Service Bulletin

Subject: Information on Active Noise Cancellation (ANC) Microphone Change and Identification Guide

Models: 2010-2014 Chevrolet Equinox
2010-2014 GMC Terrain
Equipped with Noise Control Active Interior (RPO VQN)

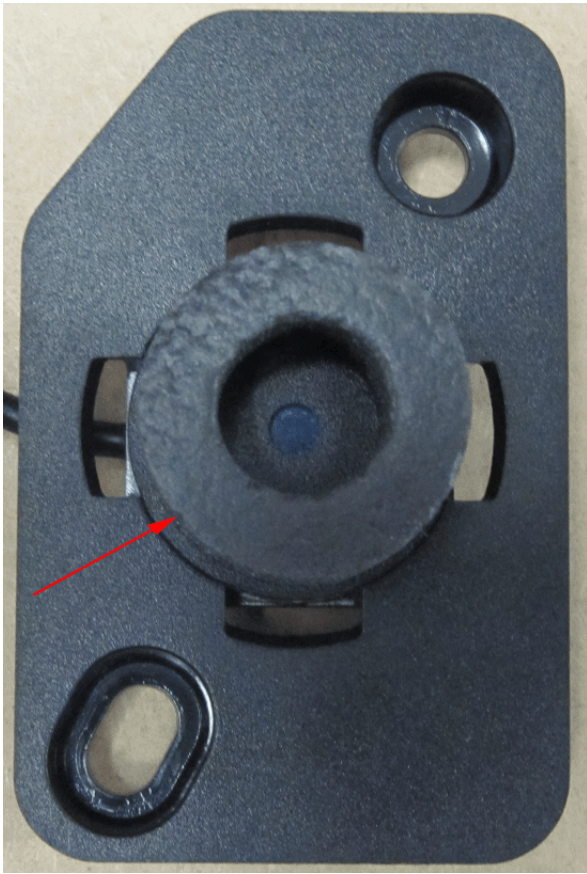
The purpose of this PI is to inform the technician when replacing the active noise cancellation (ANC) microphone, there was a design change introduced into production (see VIN Breakpoint Information below).

The two designs are not interchangeable. The two designs can be identified using the following pictorial guide below.

The old ANC microphone, P/N 25783504, has locking tabs with no mounting holes, as shown in the illustration above, which holds the microphone in place on the insulator.

The new ANC microphone, P/N 23431335, uses screws and comes with a foam ring on the face of the microphone as shown in the illustrations above.

Important: If the wrong microphone is installed into the vehicle, the system will not work.
